ADDENDUM NO. 2
TO RFP #2024-04
KEYS ROAD RESERVOIR PROJECT
DATE ISSUED: June 28, 2024

SUBJECT: CLARIFICATIONS AND CHANGES TO THE PLANS AND SPECIFICATIONS

OVERFLOW PIPE ELEVATION (C M01)

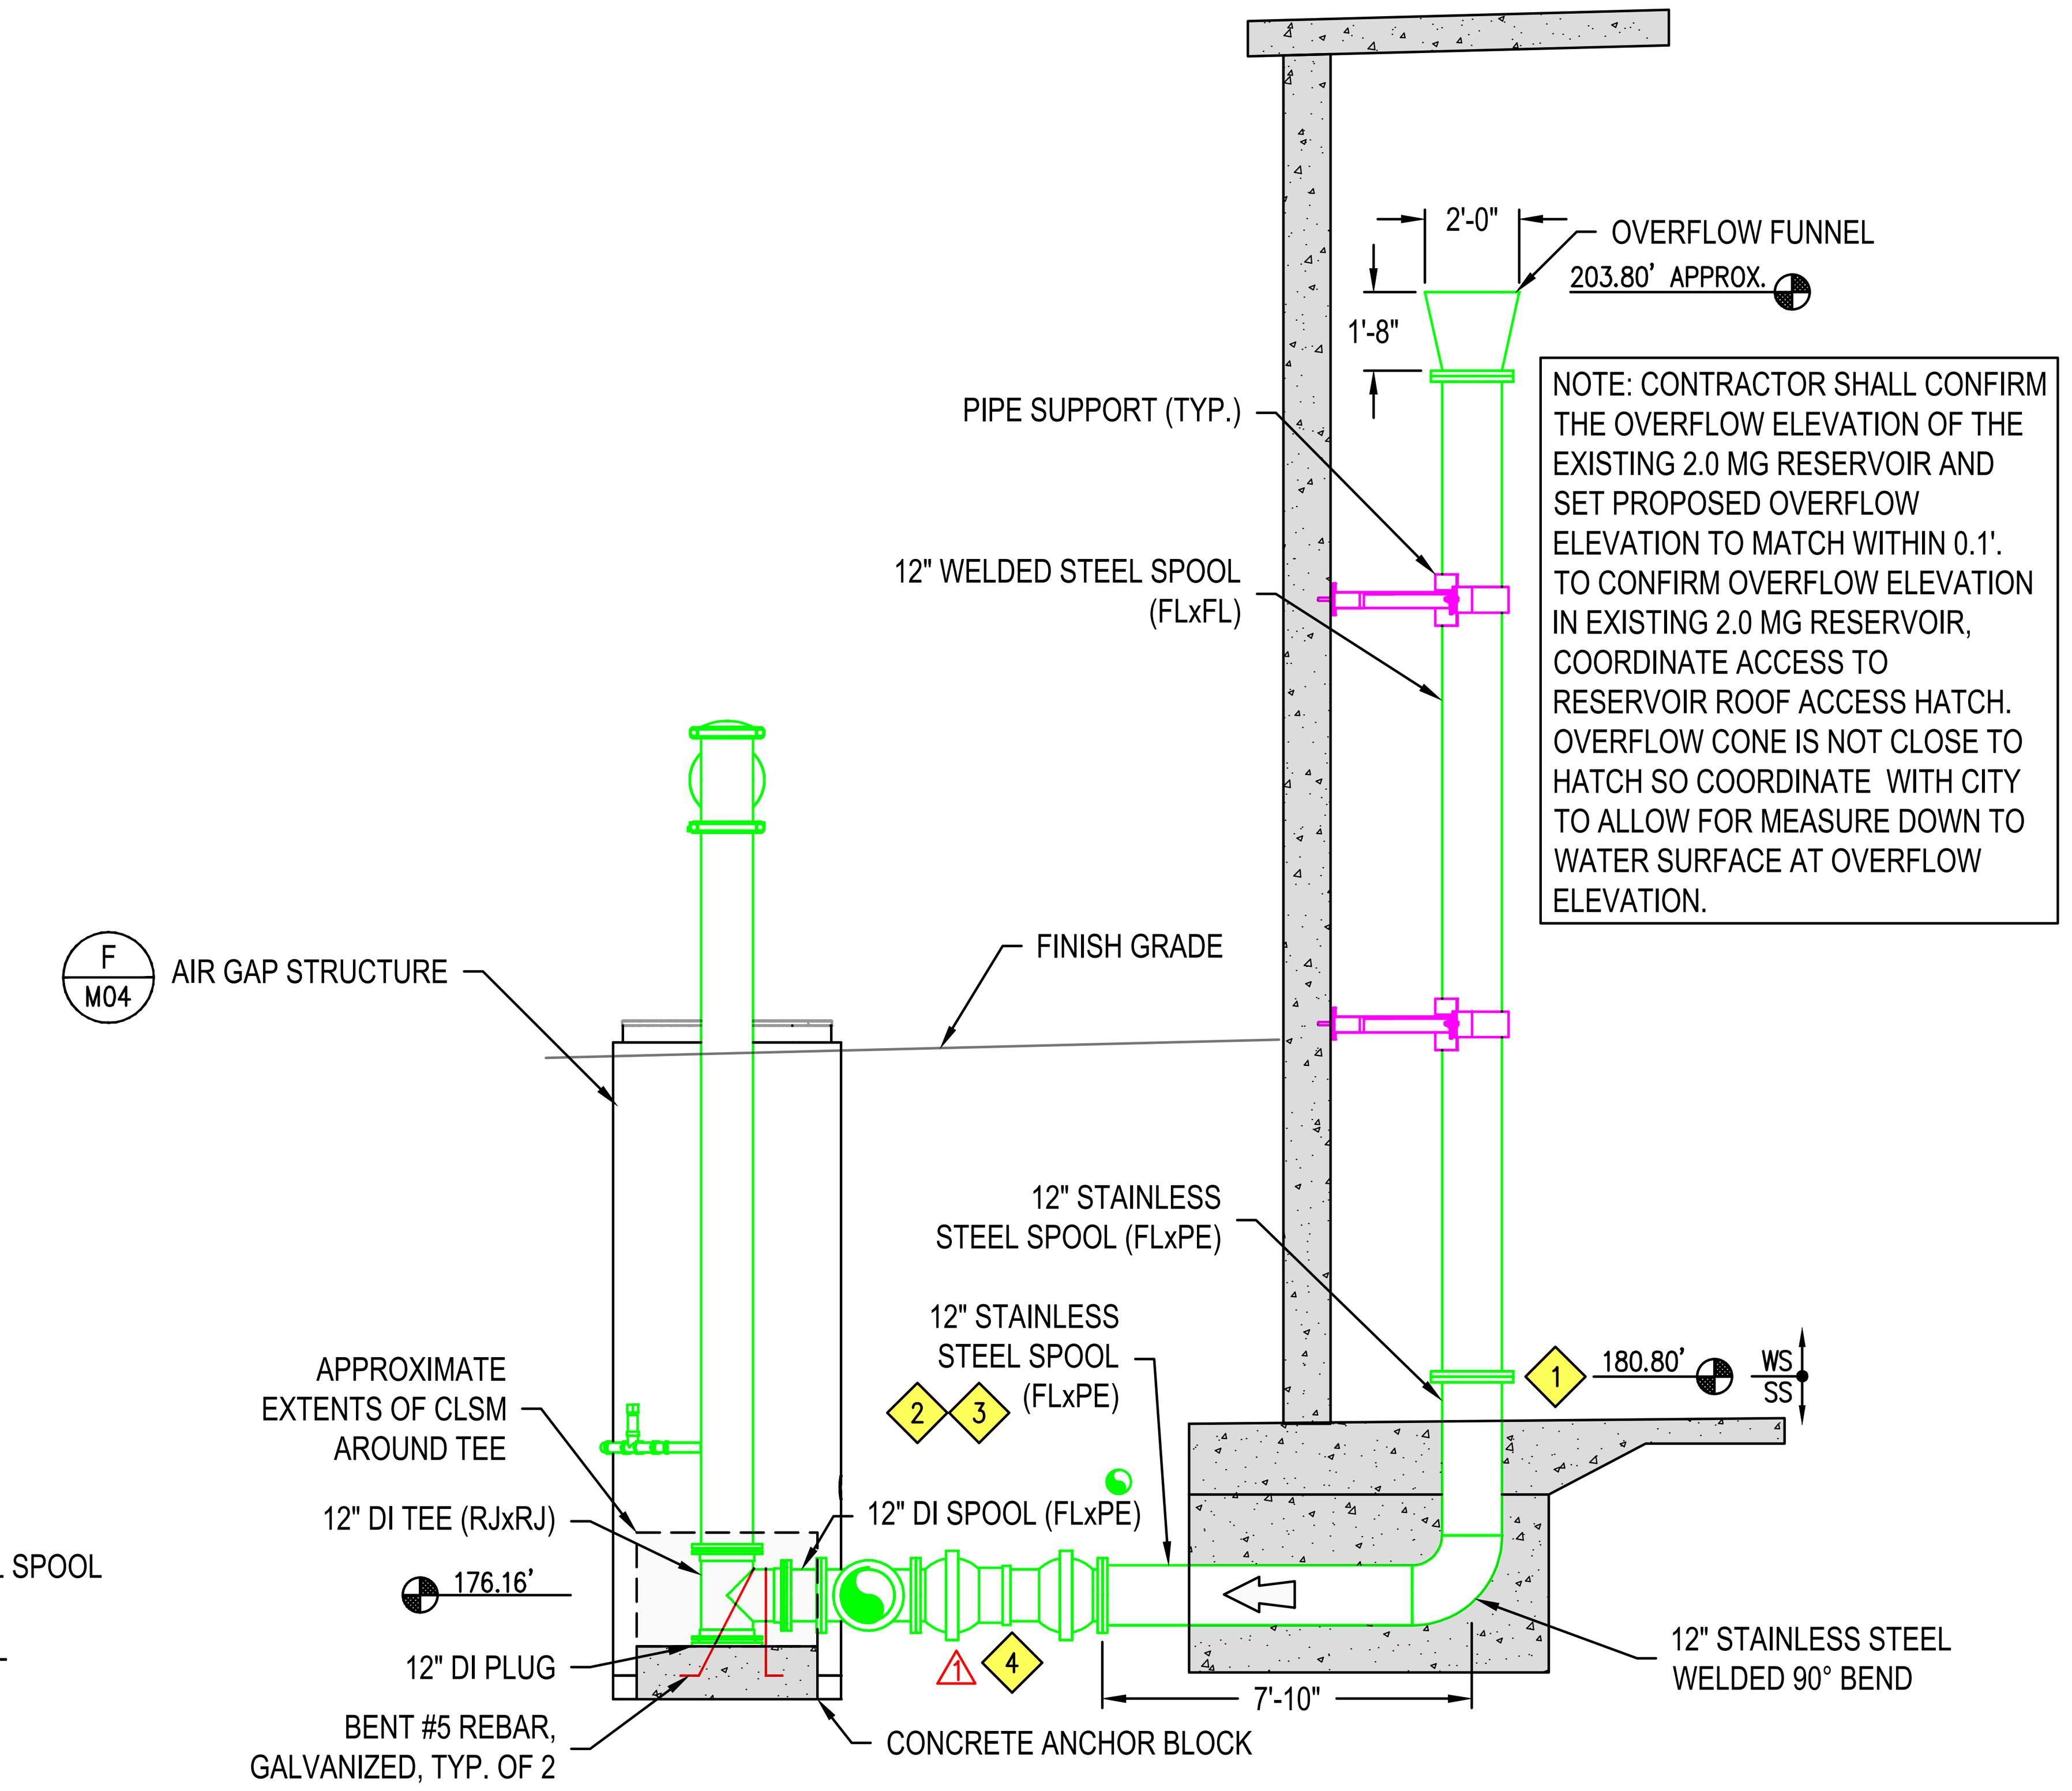
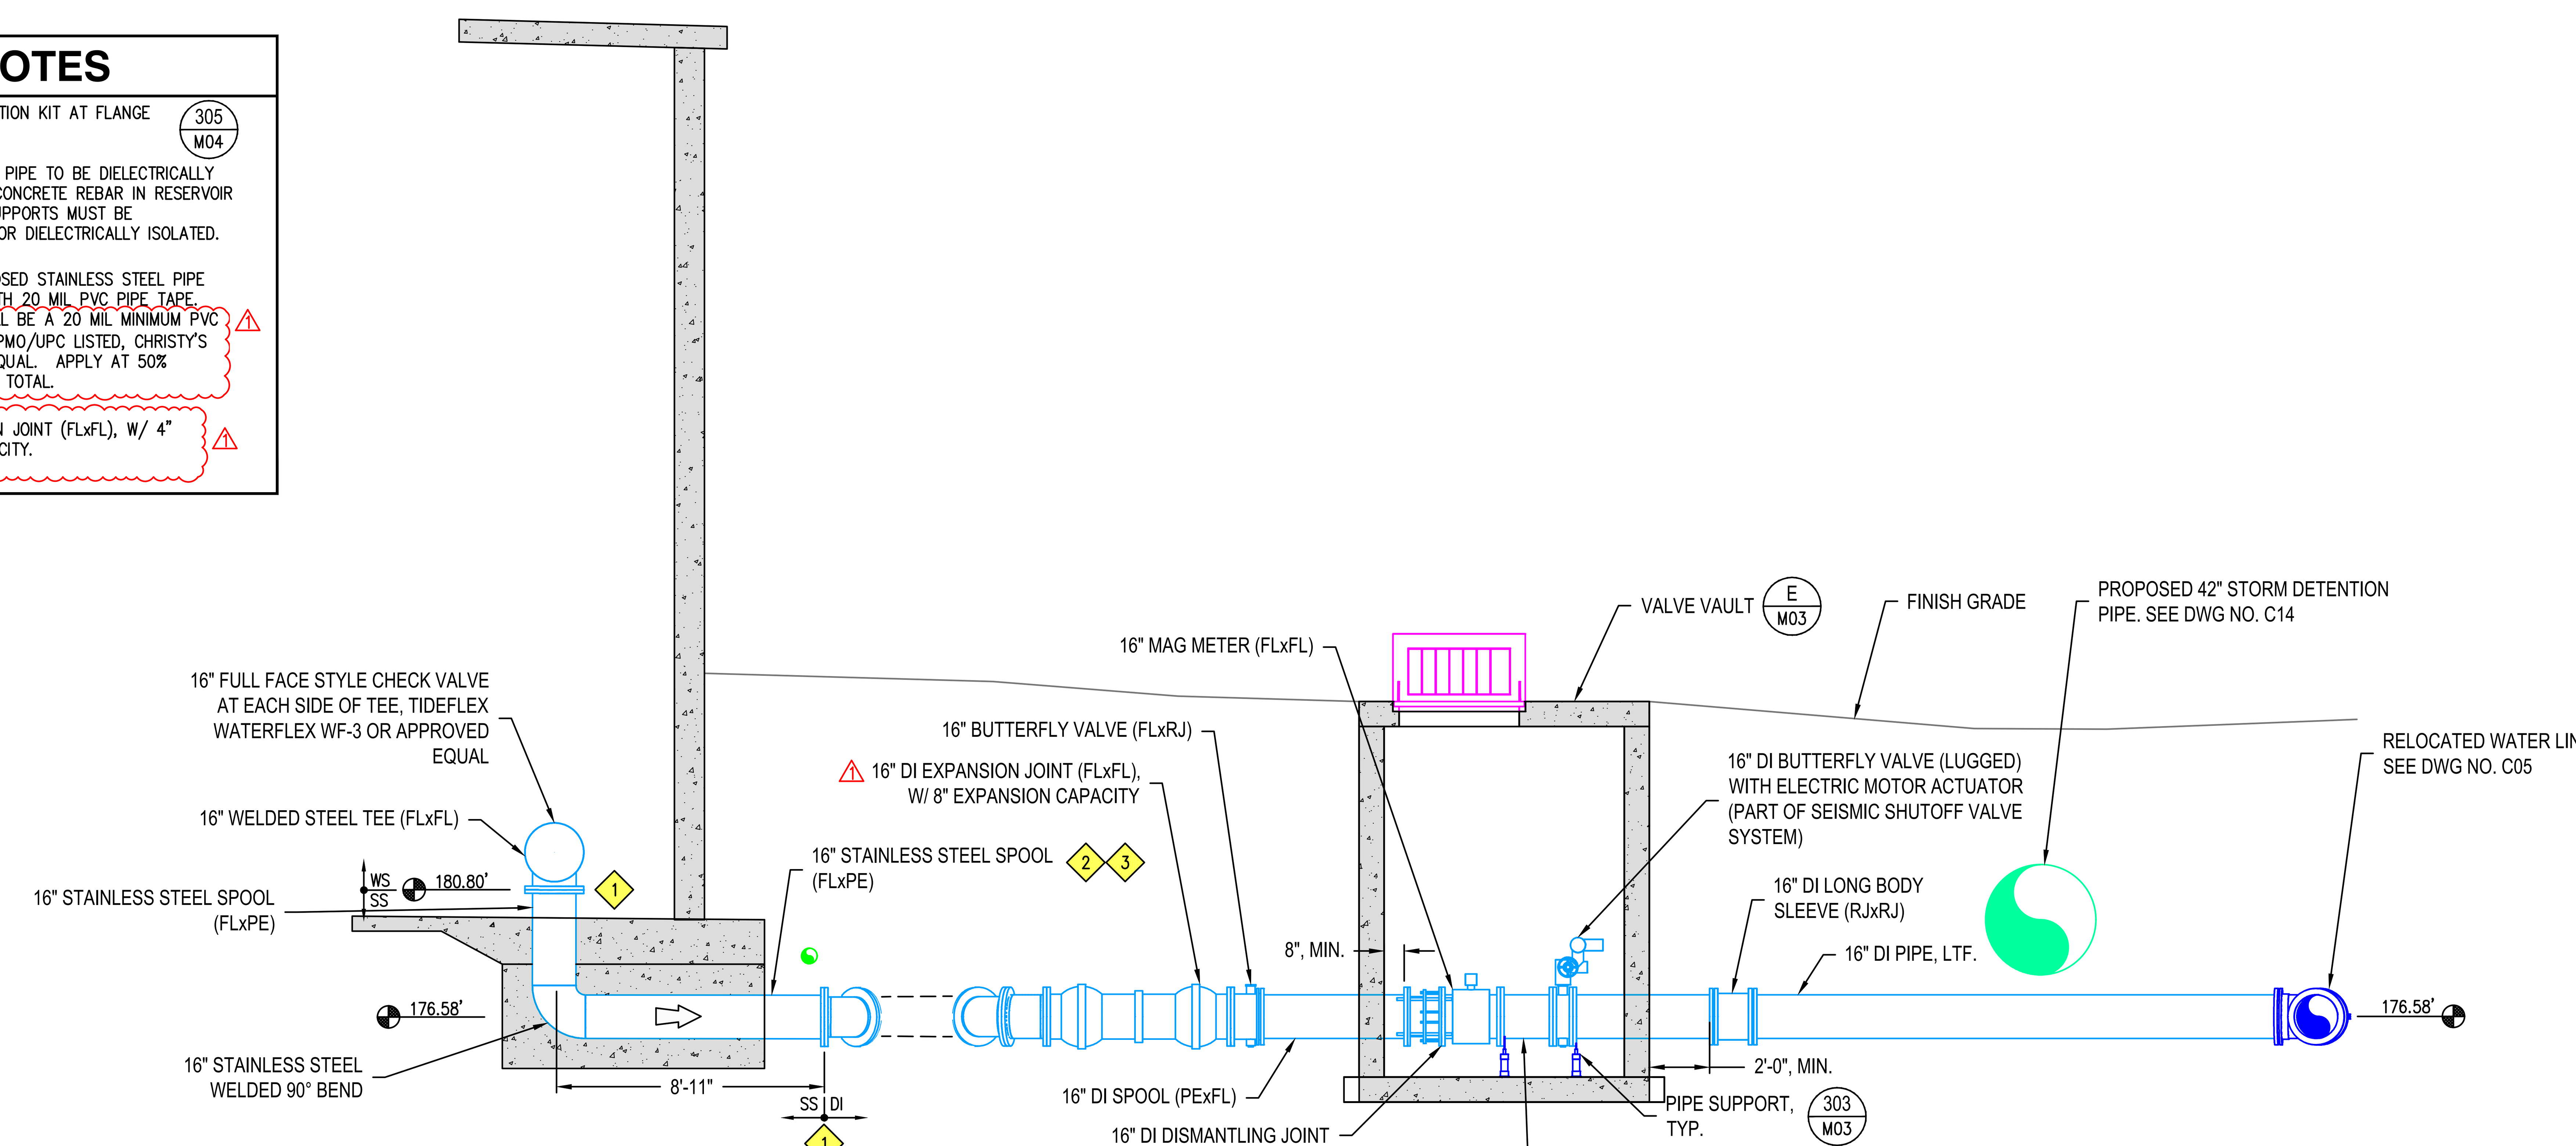
i. **Question**: Spec section 15.40.02 covers the double ball expansion joints, but does not specify the expansion required. 16" Flex-Tends are available with 8", 16", or 24" of expansion while 12" Flex-Tends are available with 4", 8", or 12" of expansion. Please clarify what is required here.

y. **Question**: Drawing M02 shows the pipe penetrations to the reservoir and both the 16” and 12” stainless steel embedded piping are shown with an oddball radius on the 90 elbows. Standard radius 90 elbows in steel and stainless steel are 1.5 X the pipe diameter.

z. **Question**: Drawing M02 in key note 3 requires tape wrap on exposed stainless steel pipe and flanges. Could you provide more information? The areas indicated for wrapping appear to be just the buried portion not embedded in concrete – is that correct? Is any primer required for the tape? Is there a minimum overlap? And can you provide a manufacturer and model of tape?

Answer: Refer to re-issued Dwg M02 in this addendum for updated information.

Answer: Graphical display of bends on steel piping are not dimensioned on the drawings and are only for representation purposes. Bend radii and other dimensions shall be provided according to the specified standards.

Answer: The tape wrapping referenced on Dwg M02 is required only on the exposed (buried) portion of the indicated piping. Refer reissued Dwg M02 as part of this addendum for tape wrap information.

1. DIELECTRIC ISOLATION KIT AT FLANGE CONNECTION. (305 M04)
2. STAINLESS STEEL PIPE TO BE DIELECTRICALLY ISOLATED FROM CONCRETE REBAR IN RESERVOIR FOOTING. PIPE SUPPORTS MUST BE NONCONDUCTIVE OR DIELECTRICALLY ISOLATED.
3. TAPE WRAP EXPOSED STAINLESS STEEL PIPE AND FLANGES WITH 20 MIL PVC PIPE TAPE. TAPE WRAP SHALL BE A 20 MIL MINIMUM PVC TAPE THAT IS IAPMO/UPC LISTED, CHRISTY'S PIPE WRAP OR EQUAL. APPLY AT 50% OVERLAP, 40 MIL TOTAL.
4. 12" DI EXPANSION JOINT (FLxFL), W/ 4" EXPANSION CAPACITY.
